PCN – Process Change Notification

Change:	AA.107.301111
Date:	2017/03/08
Author	Haley Tsai

Model#	Part Number	Changes
AA.107 - Stingray Adhesive Mount - GPS/GLONASS 3000mm RG174 SMA(M)ST	AA.107.301111	<ol style="list-style-type: none"> 1. Add WEEE Heatshrink Tube 2. Amend Label Orientation 3. Amend Housing Dimension 4. Amend Housing Material 5. Amend dimensions between two labels

Old drawing

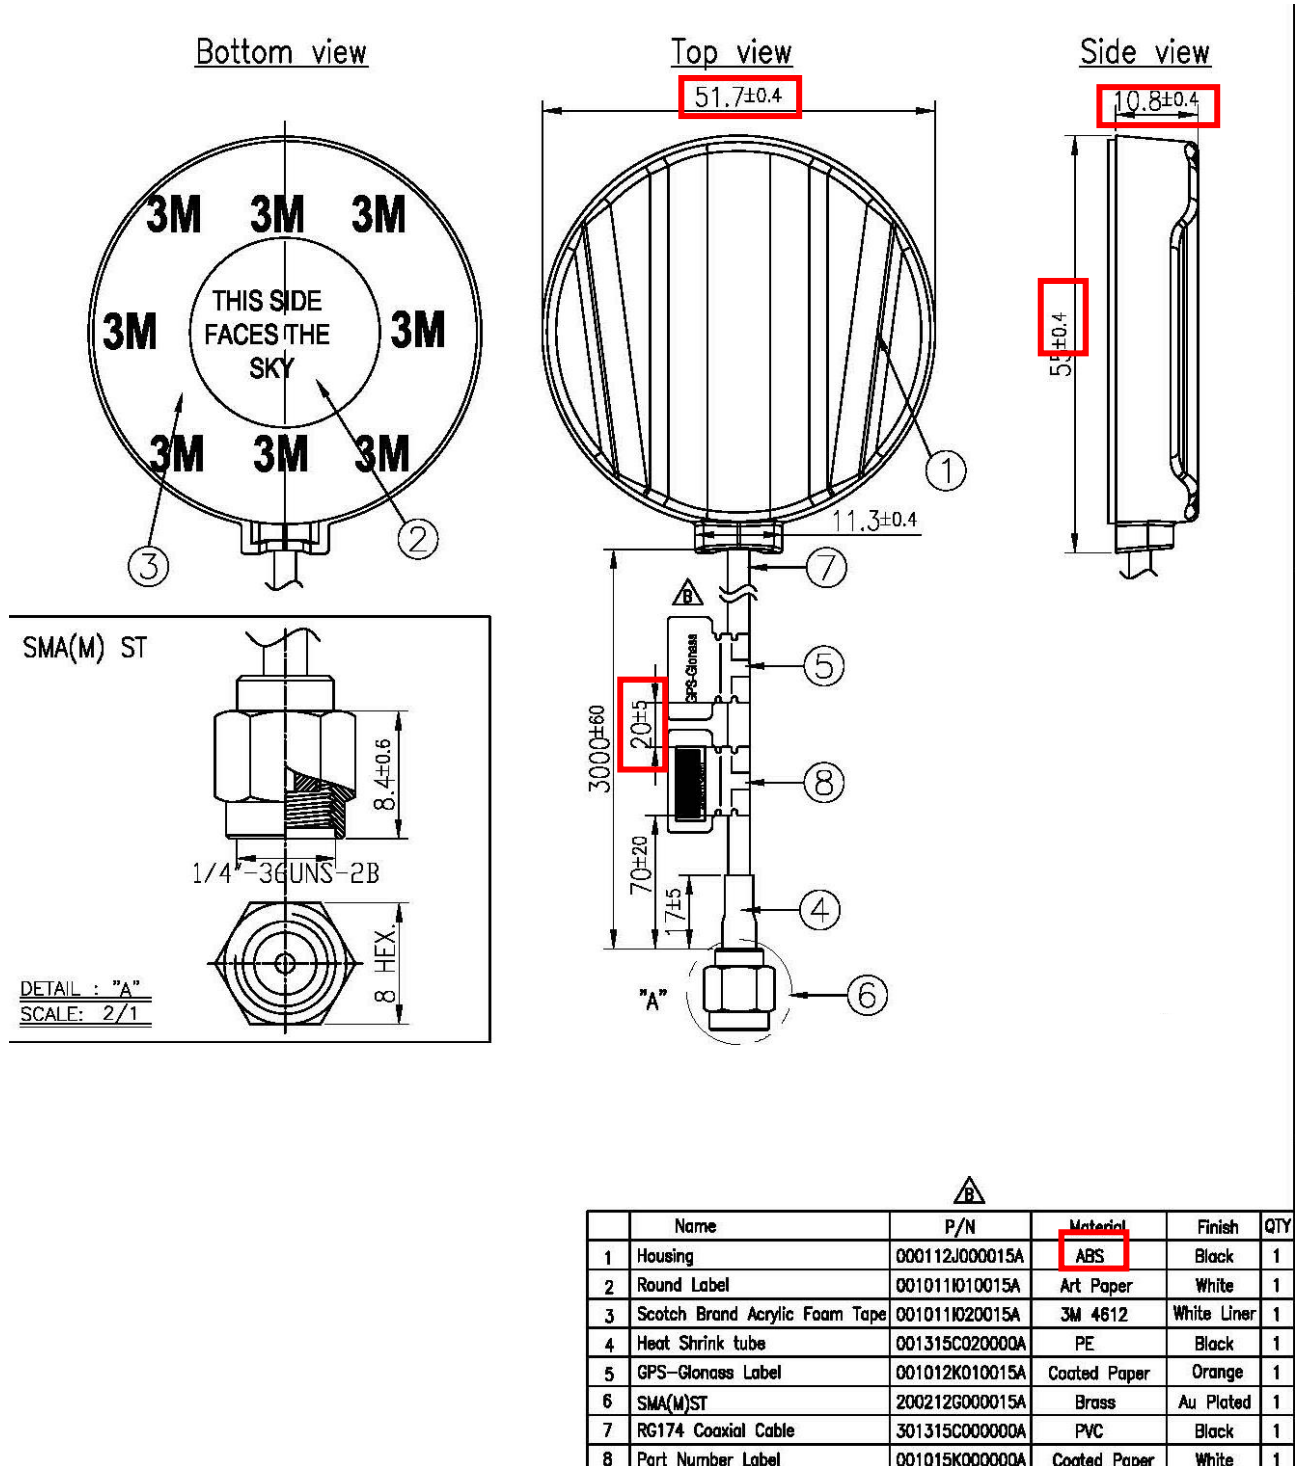
1. Add WEEE heatshrink tube.
2. Amend label orientation.
3. Amend housing dimension from 51.7mm to 51.4mm.
4. Amend housing dimension from 10.8mm to 11.7mm.
5. Amend housing tolerance from 0.3mm to 1.0mm.
6. Amend Housing Material from ABS to PC.
7. Amend dimensions between two labels from 20mm to 10mm.
